TECHNICAL MEMORANDUM

PEER REVIEW OF SACRAMENTO VALLEY FINITE ELEMENT GROUNDWATER MODEL (SACFEM)

U.S. Bureau of Reclamation

October 2011

Figure 8. Groundwater Pumping for 2000 (normal hydrological conditions).
 (Some of the areas with excessive groundwater pumping are identified with red circles.)

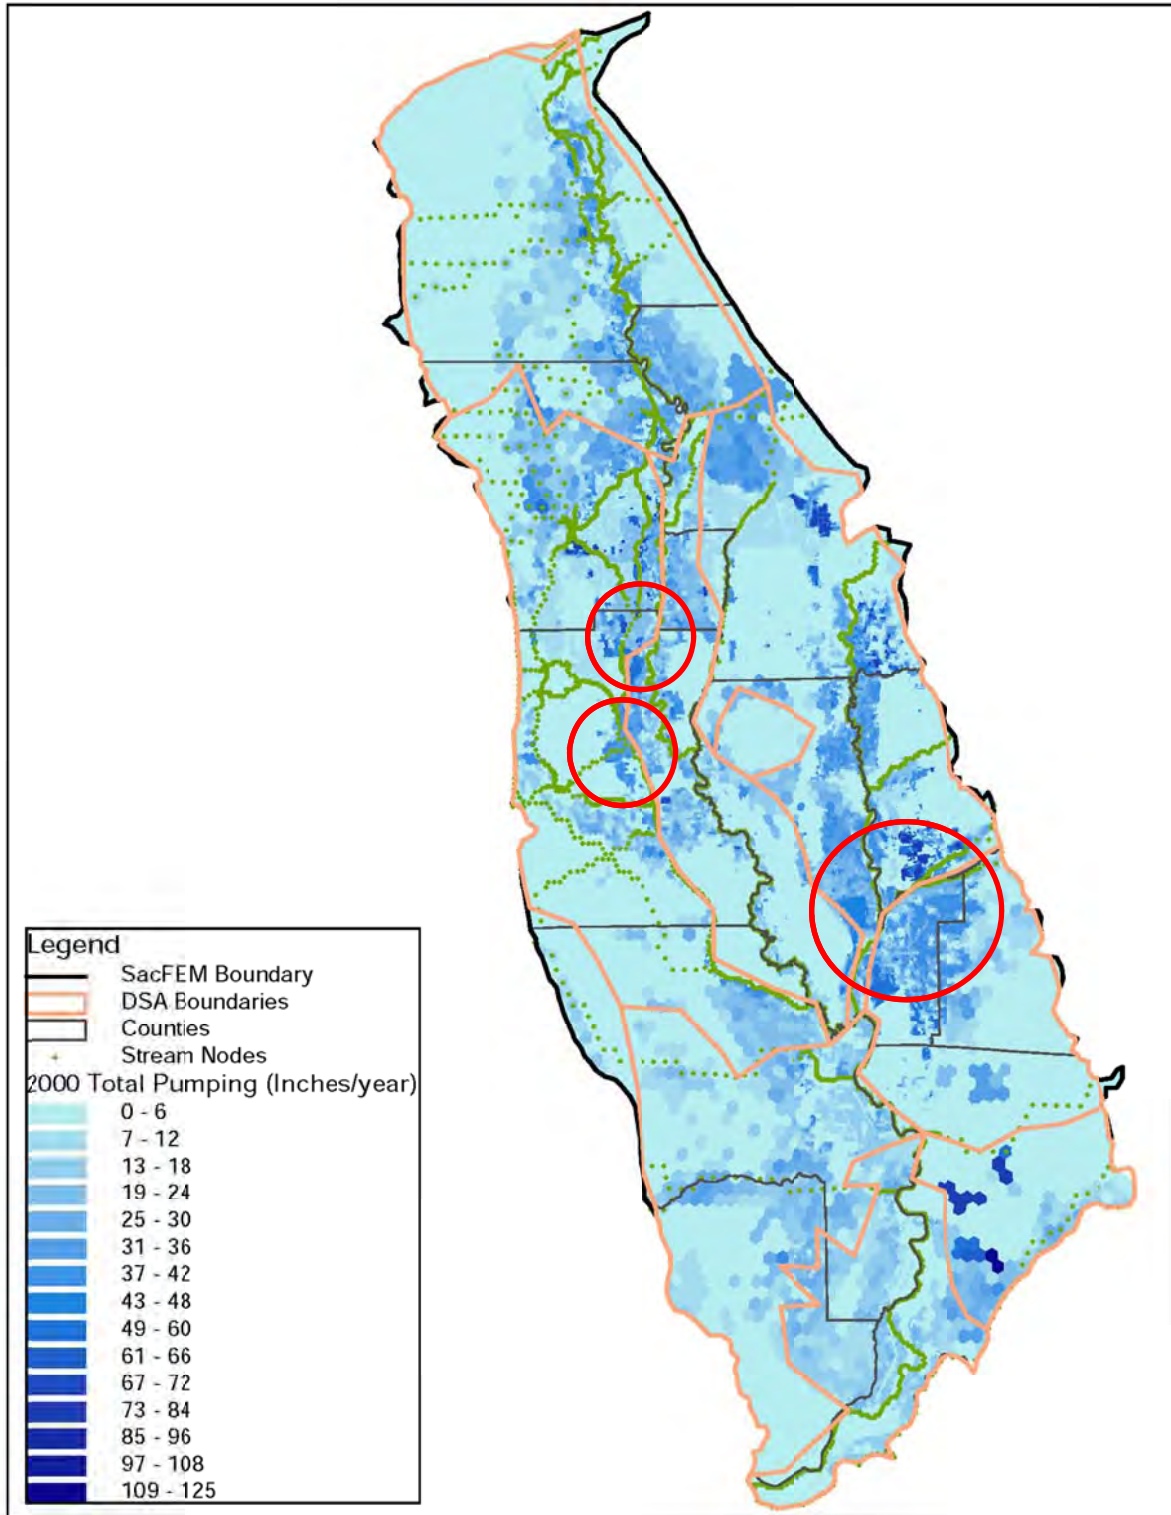
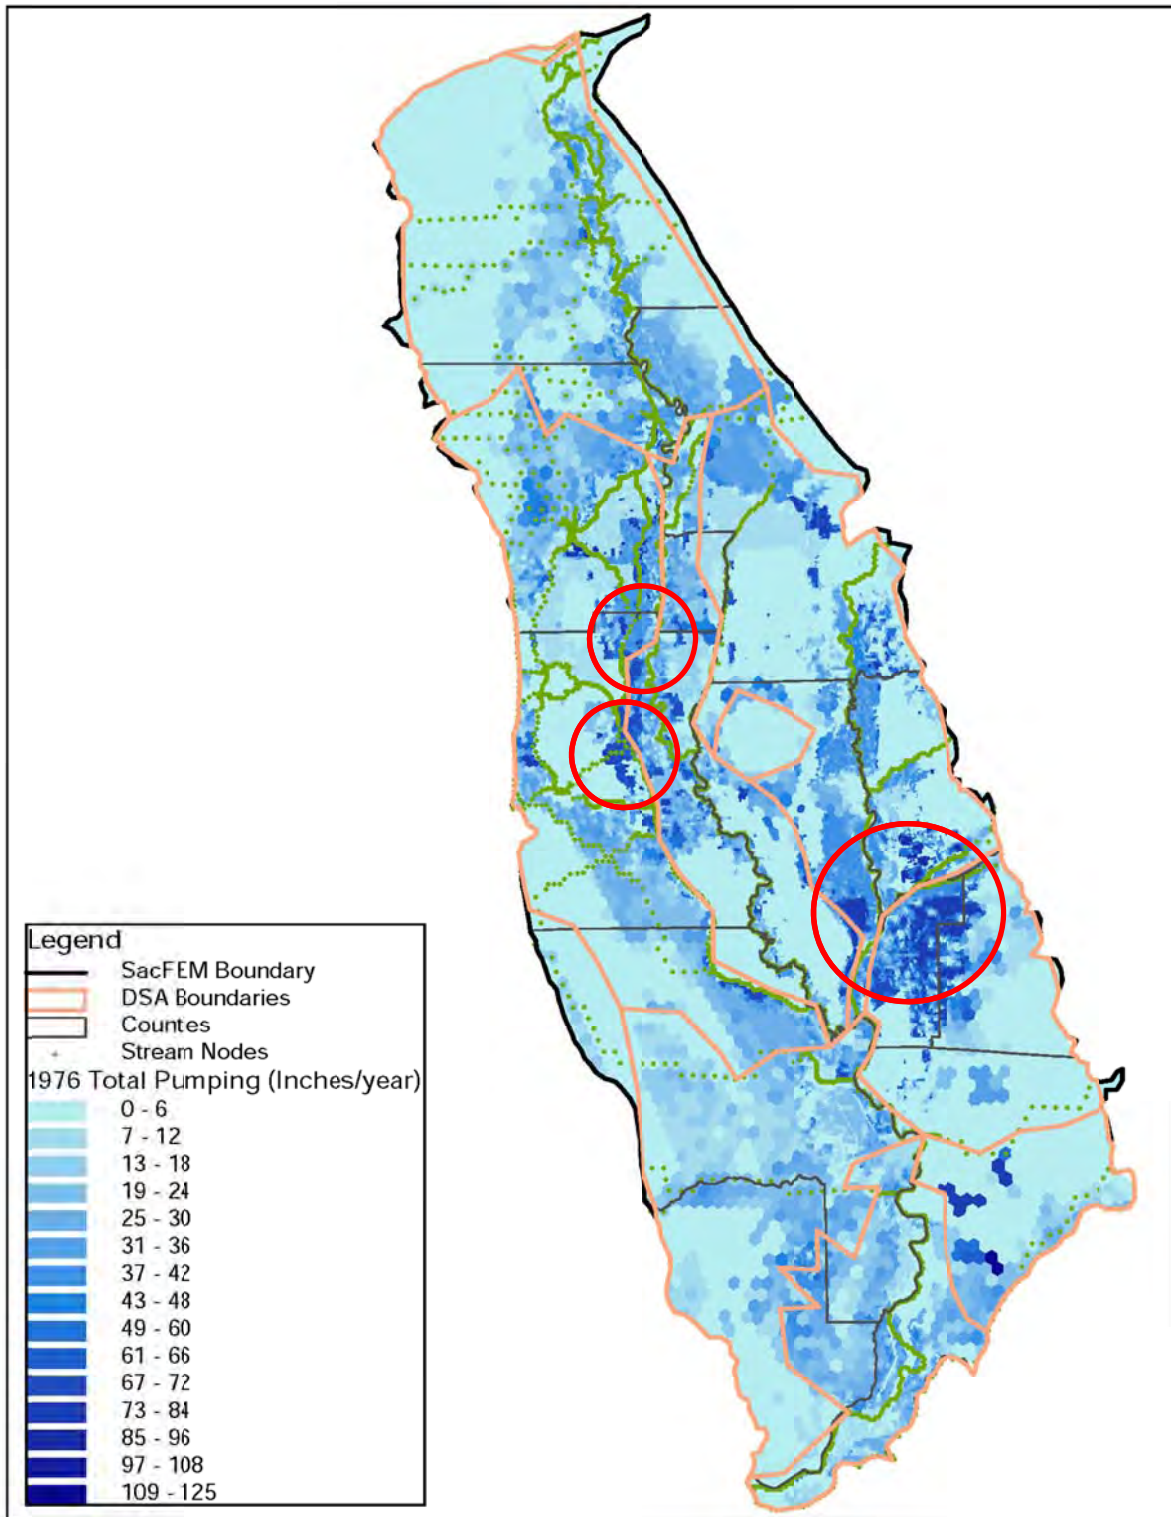
Agricultural water demand estimates vary based on hydrological conditions. As a result, agricultural groundwater pumping estimates are highest in dry years and lowest in wet years. Groundwater pumping distributions for normal, dry, and wet hydrological conditions are presented in Figures 8, 9, and 10, respectively. The groundwater pumping maps for years 1976 (Figure 8) and 2000 (Figure 9) show excessive pumping in some areas where surface water appears to be available (Figures 7). In contrast, groundwater pumping distribution for 1983 (Figure 10) is consistent with the water supply mix map (Figure 7). Some of the areas with excessive pumping are marked on Figures 8 and 9.

Updating the land use and crop acreage data for historical conditions will result in changes in agricultural demand rates. It is recommended to verify the agricultural demand calculations against the update of the land use and crop acreage data. It is recommended to use available historical surface water delivery data for calculation of historical agricultural groundwater pumping. Historical agricultural groundwater pumping rates should be re-estimated based on historical agricultural demand and surface water delivery data.

Figure 12. Distribution of IDC Deep Percolation Rates from Precipitation

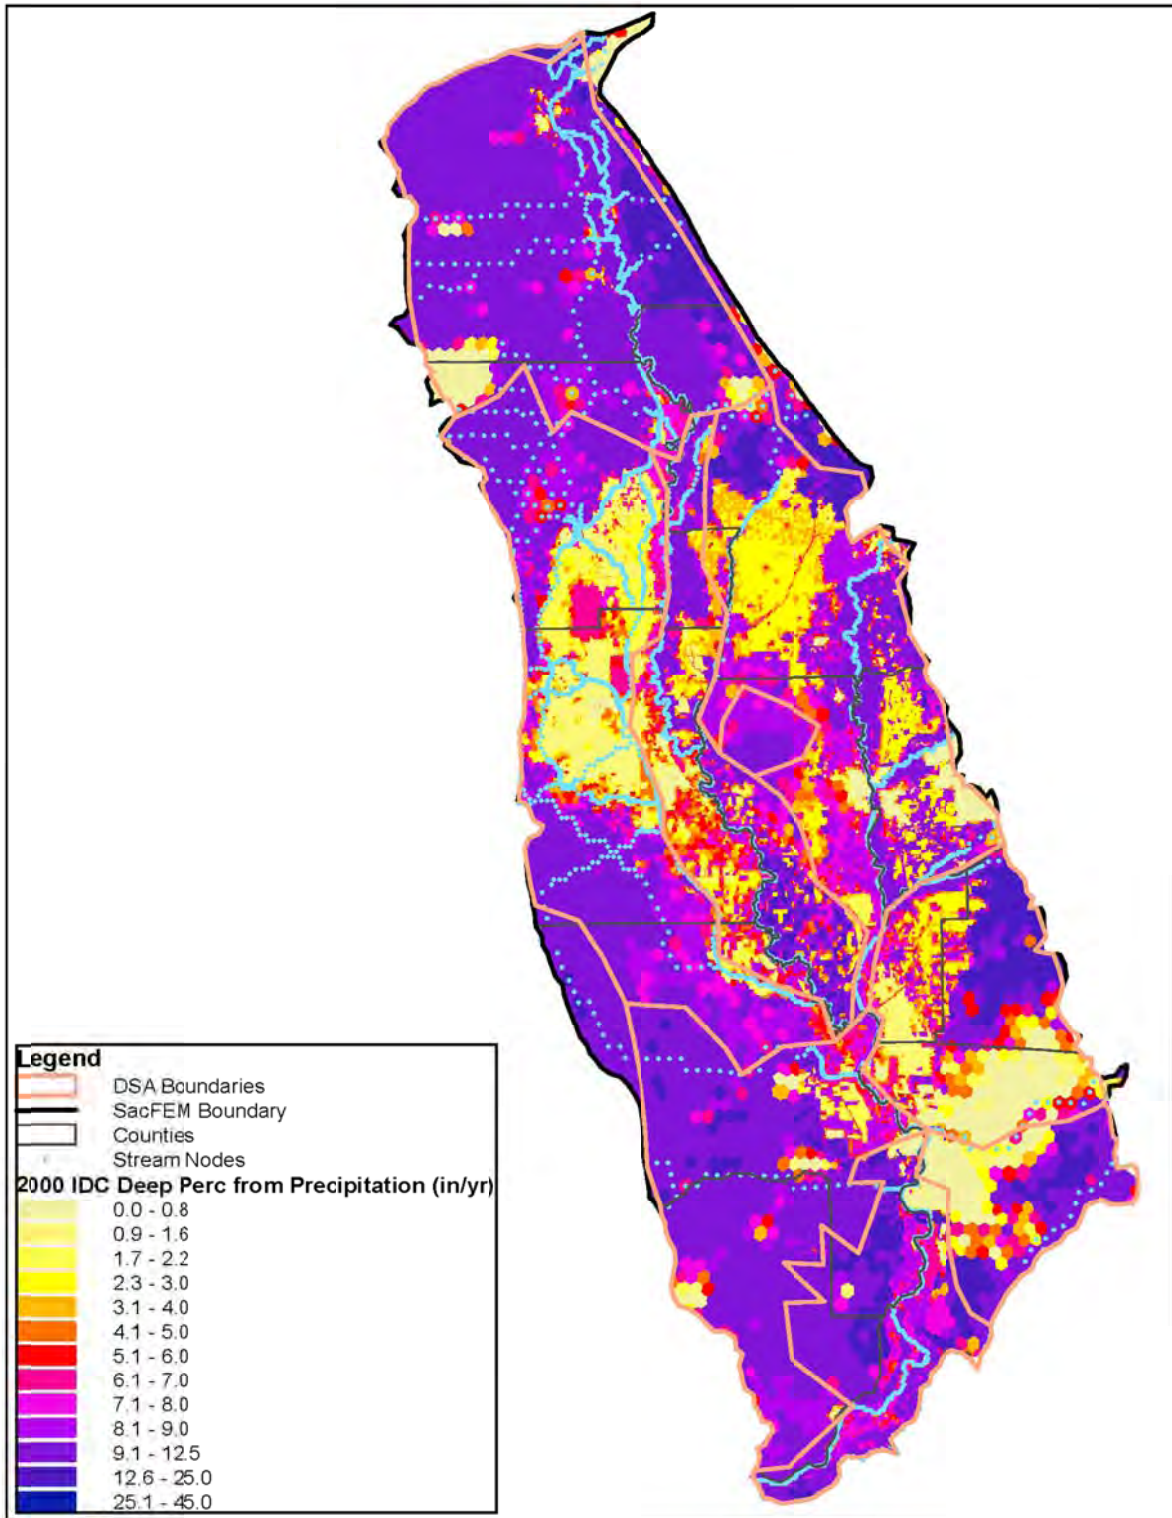
Deep percolation rate, in part, depends on hydrological soil types (Figure 1). Soil type A has the highest deep percolation rates and soil types D has the lowest deep percolation rates for the same precipitation rates. Distribution of hydrological soil types in the Sacramento Valley is presented in Figure 11. Distribution of the IDC model deep percolation rates from precipitation is presented in Figure 12. Estimates of deep percolation rates from precipitation are excessive, as high as 45 inches per year in some areas. Additionally, distribution of deep percolation from precipitation is not consistent with soil type and precipitation distribution.

Figure 13. Distribution of ICD Deep Percolation Rates from Applied Water

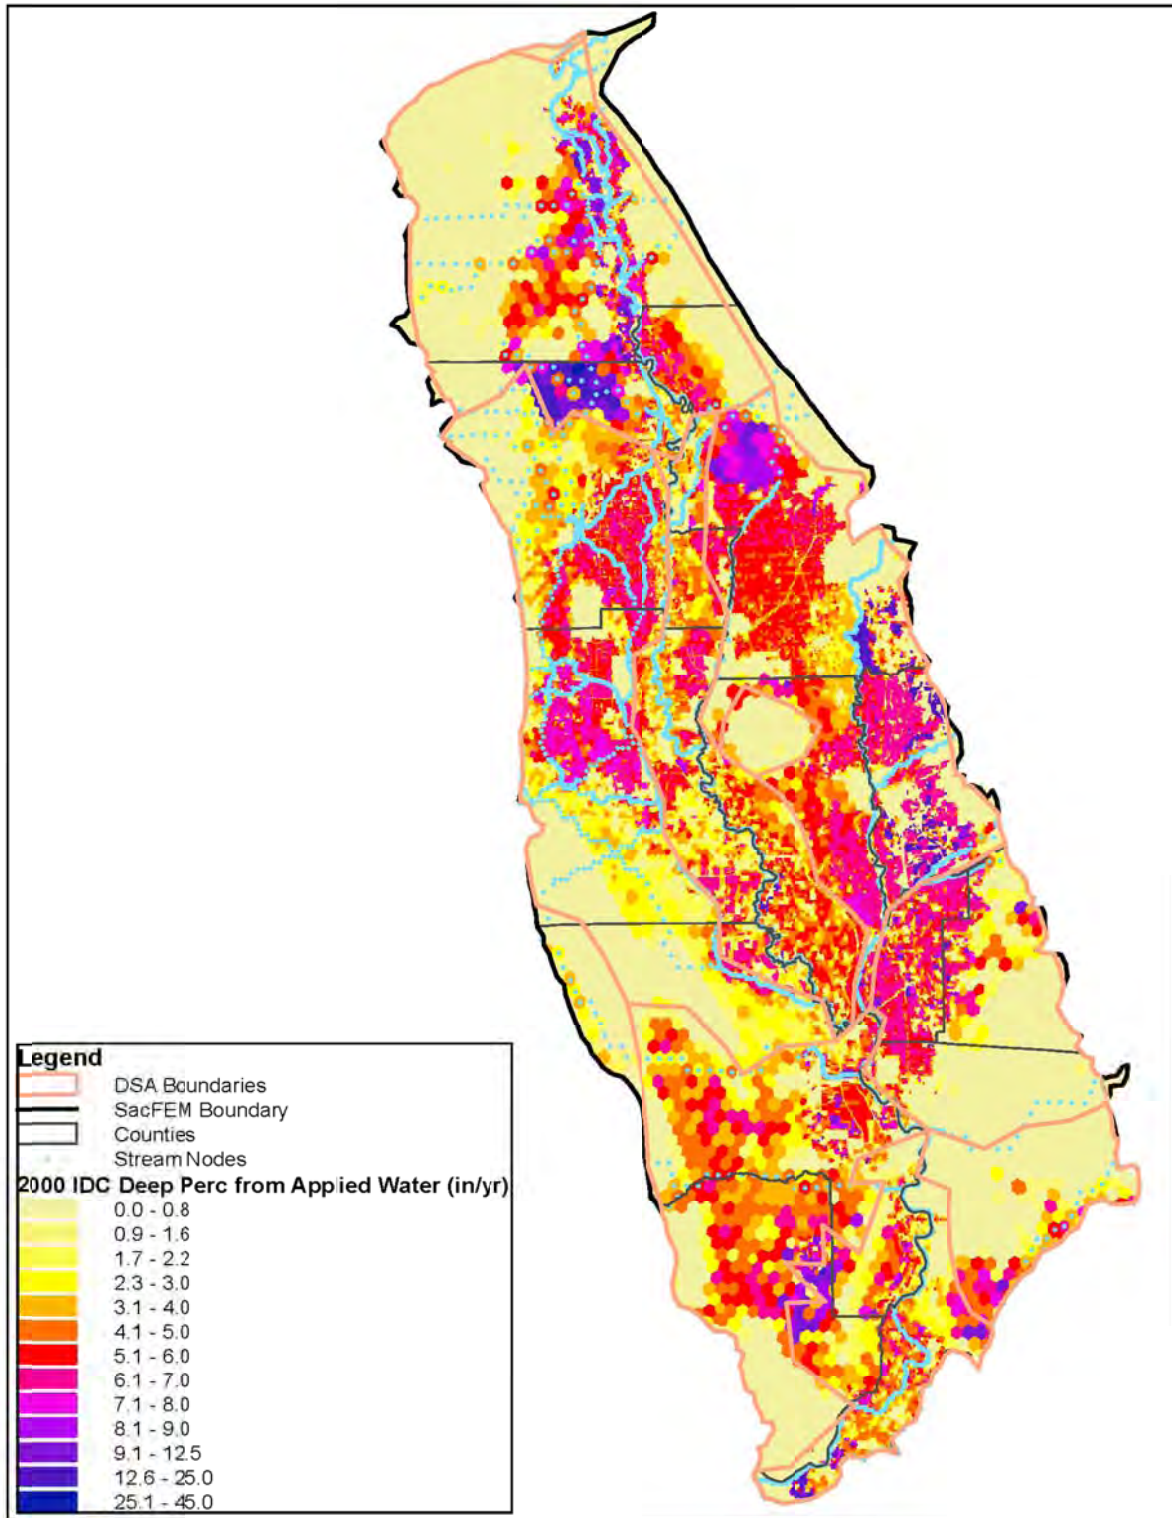
Distribution of the IDC model deep percolation rates from applied water is presented in Figure 13. The IDC model estimates excessive deep percolation rates from applied water and the distribution of deep percolation is not consistent with soil type. Distribution of the IDC model total deep percolation rates from precipitation and applied water is presented in Figure 14. The IDC model estimates excessive deep percolation rates, as high as 45 inches per year, with a distribution that is not consistent with soil type and surface water distribution.
